### Hydraulic Modelling Addendum

Job Name            Peartree Hill Solar Farm

Job number        20-206

Date                    26<sup>th</sup> November 2025

Figure 2-1 CFMP catchment sub-areas

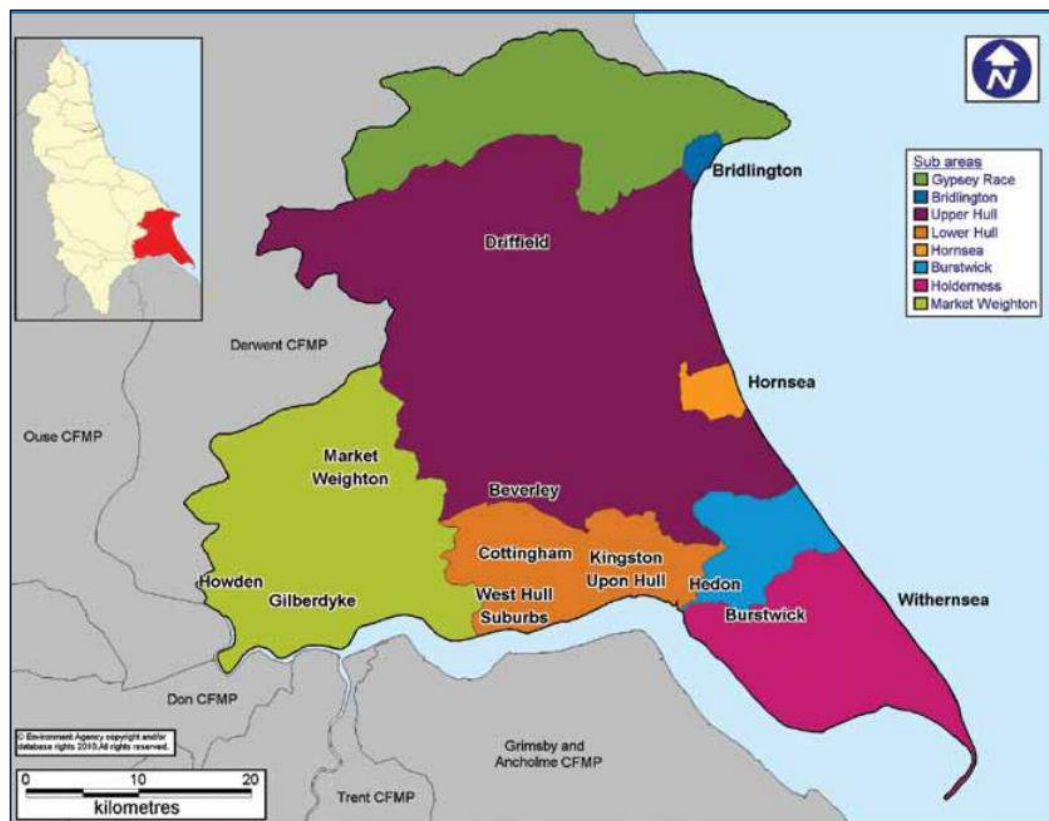
*“Although breach modelling is being undertaken by the applicant, any assessment of residual flood risk, both now and in the future, will be insufficient without further consideration of the condition of the flood defences. Through understanding the condition of existing defences*

*and how defence conditions may change over the lifetime of the development, you must give appropriate consideration to how residual flood risk can be managed and mitigated.”*

The defences alongside the Humber Estuary fall within Lower Hull catchment sub-area (as shown in **Error! Reference source not found.**). The policy for this area is to “take action to further reduce flood risk”.

- 2.2.2 There have recently been significant defence improvements in the area generally consisting of flood embankments and walls which have been designed so a managed adaptive approach can be taken – i.e. so that

- 2.2.3 Give the commitment to defences in this area, the fact that they protect thousands of properties in the City of Hull and that tidal flooding would be significantly attenuated before reaching the site no further investigation is considered necessary, as agreed with the Environment Agency during a meeting on 1<sup>st</sup> July 2024.

*Figure 3-1 Missing Structures*

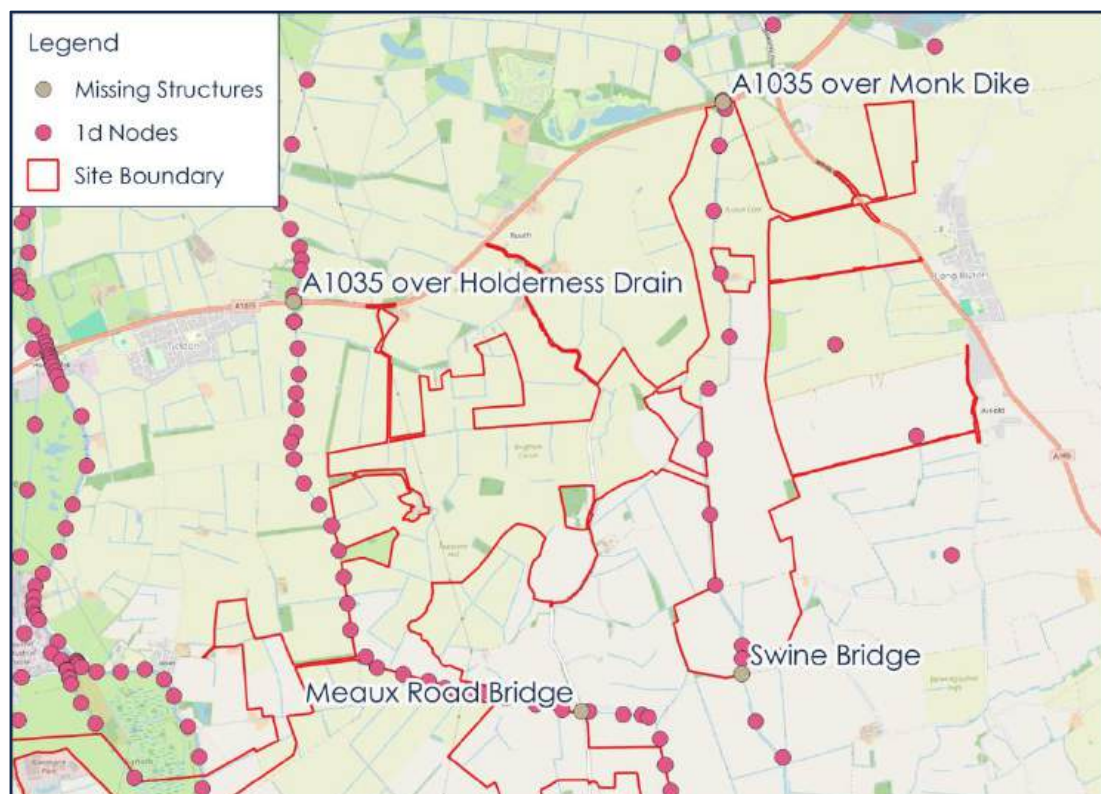
3.1.1 The EA model review notes a number of missing structure in vicinity of the site as listed below and shown in Figure 3-1 Missing StructuresFigure 3-1:

- A1035 bridge over Monk Dike (FM cross section Cat000000)
- A1035 bridge over Holderness Drain (FM cross section HN43),
- Swine Road Bridge over Monk Dike (closest FM cross section MK4055), and
- Meaux Road Bridge over Holderness Drain (FM cross section HN21).

3.1.2 Three of these structures have been added to the model using available data and where information was sparse a conservative approach to the structure definition was taken. The structure at HN21 as it appears to be a clear span structure with the deck approximately 3m above the maximum water level. Structure details definitions are appended to this document.

3.1.3 The model was reran with the design event flood. The maximum flood level was compared with the existing baseline design event outputs and the results are shown in Drawing 20-206-60-255-00 & 20-206-60-256-00.

3.1.4 Flood levels are generally within +/-20mm within the site boundary, the exception being a small part of parcel B1 where levels are reduced by 60mm and land west of parcel F12 where levels are reduced by 180mm. The only significant increase within the site are the parcels to the east of the Monk Dike (B2-4, B8 & C1-C3) where levels increase by 20mm. The change in outline is insignificant.

3.1.5 Given the very minor changes experienced in flood levels across the site it is concluded that the definition of these structures has no material impact on the flood levels, the mitigation (a freeboard of 300mm has been applied), or the layout.
